## **APPENDIX B**

### **Responses to NRC Requests for Additional Information (RAI) Air Quality**

**Figure 1: 10-Year Monthly Temperature Comparison**

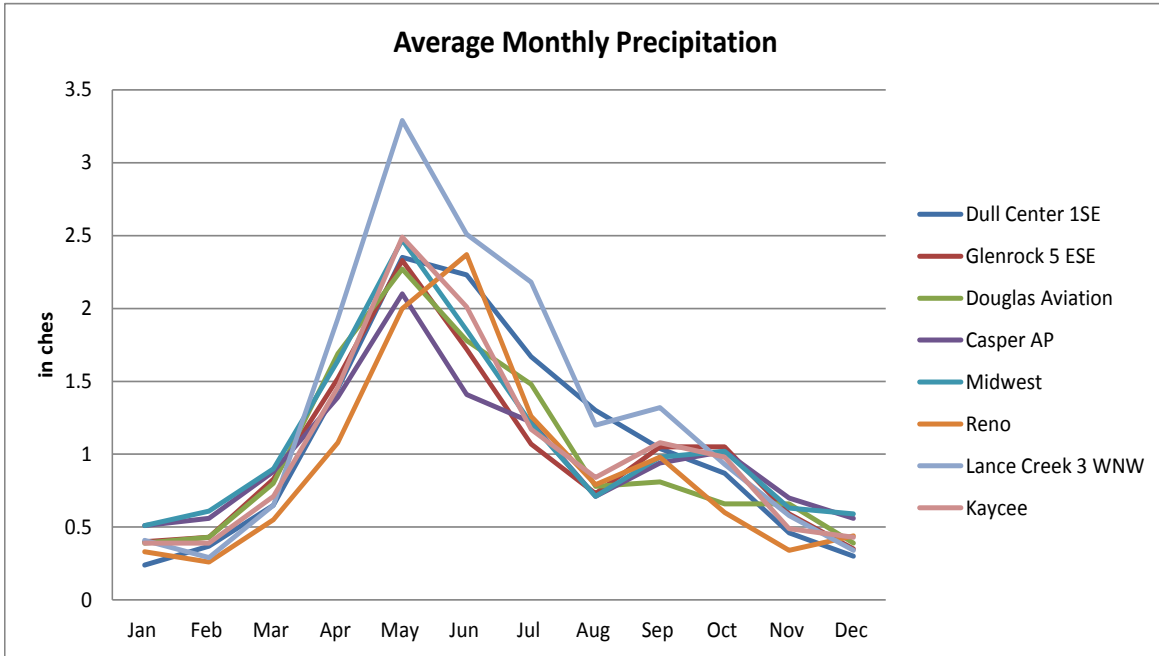
- A. Please confirm that the 2005 and 2007 data described in Section 3.6.1 are the best available data to characterize the meteorological conditions at the Ludeman Project or update the data with the most current information. Also, please include a map identifying the locations of monitoring stations relative to the Project area.*
- B. Newcastle is listed in Table 3.6-1 of the ER as one of the meteorological stations included in the climate-change analysis. Please address the absence of data for Newcastle in the text and subsequent figures.*

The period of record presented in the ER was based on available data at the time that it was originally developed. While the long-term regional climatic conditions tend to remain relatively stable over time, the tables and figures below have been revised to reflect the most recent meteorological data available.
